# SERVICE BULLETIN

M-1082

Safety Recall Code 096

## SCREAMIN' EAGLE RACE BRACE SUPPORTS

Figure 1. Race Brace Support (FXST)

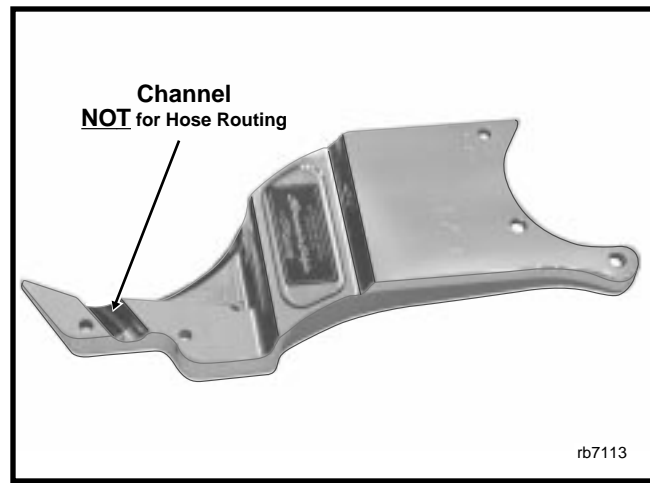
Channel on inboard side of race brace support is for routing of the ignition sensor wires on older model vehicles (where the groove in the gear cover is absent) and **NOT** for routing of the rear brake master cylinder reservoir hose. If hose is routed on inboard side of brace, begin at step 1. If hose is outboard of brace, start at step 9.

1. After loosening rear exhaust pipe and muffler, completely remove front exhaust system.
2. Remove three allen head socket screws at bottom of gear cover to release front of race brace support.
3. Place drain pan under transmission case.
4. Remove six allen head socket screws to release clutch release cover.
5. Pulling clutch release cover away from vehicle, remove three allen head socket screws to release rear of race brace support from transmission side door.
6. Reinstall race brace support moving rear brake master cylinder reservoir hose to outboard side.
7. Install six allen head socket screws to fasten clutch release cover to transmission side door.
8. Add transmission fluid to compensate for any loss during removal of the clutch release cover.
9. Using a side cutters, cut hose clamps at each end of reservoir hose. Remove and discard hose clamps.

Figure 2. Proper Hose Routing/Cable Strap Locations (FXST)

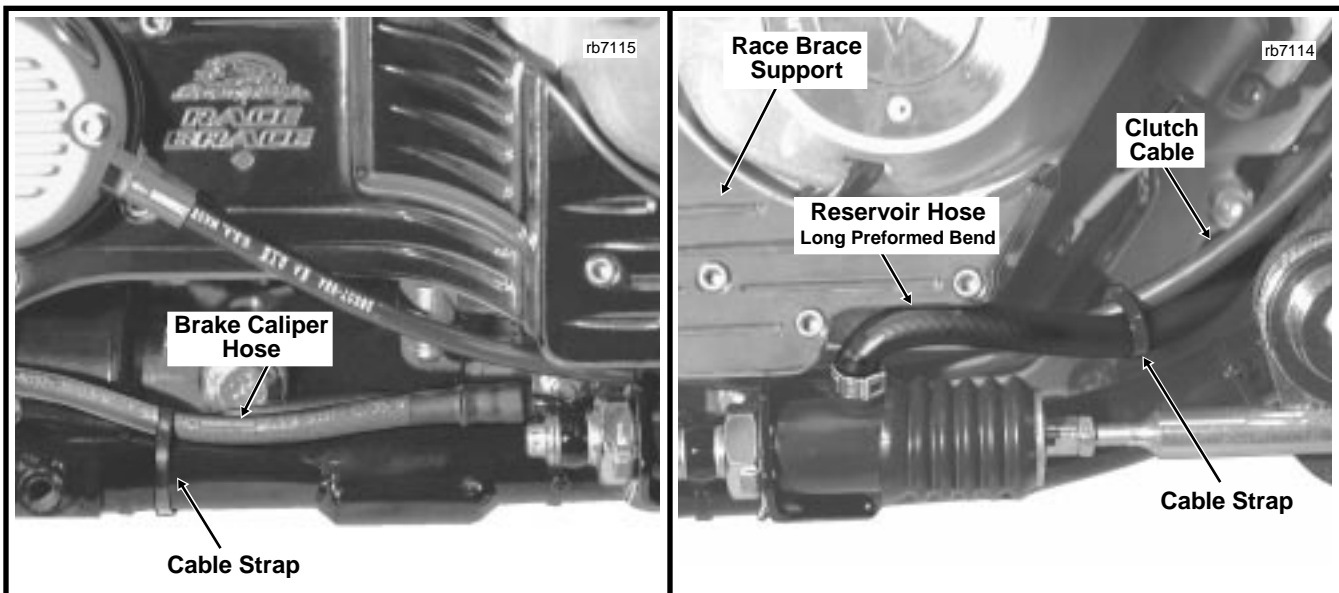
12. Install hose onto fitting at top of master cylinder. To prevent kinking of hose at bottom of race brace support, hose must be flipped 180 degrees from its original position, so that end with long preformed bend is on the master cylinder side. See right frame of Figure 2.

13. Slide **new** hose clamp (Part No. 10038A) down free end of hose to area of master cylinder fitting. Crimp clamp.
14. Route free end of hose through cable strap that encircles right side of lower frame crossmember. If absent, loosely install new cable strap (Part No. 10006) to capture hose at this location.

15. Slide **new** hose clamp (Part No. 10038A) onto free end of reservoir hose (end with short preformed bend). Install hose onto fitting at bottom of reservoir and crimp clamp.
16. Install **new** cable strap (Part No. 10006) to secure reservoir hose to clutch cable. See right frame of Figure 2.
17. Install **new** cable strap (Part No. 10006) to secure brake caliper hose to lower frame tube. See left frame of Figure 2.
18. Add brake fluid to the master cylinder reservoir to compensate for any loss during hose replacement. Bleed the rear brake system.
19. After installing front exhaust pipe and muffler, if removed, tighten rear exhaust system.
20. Test ride the motorcycle. If the brake feels spongy, repeat the bleeding procedure.
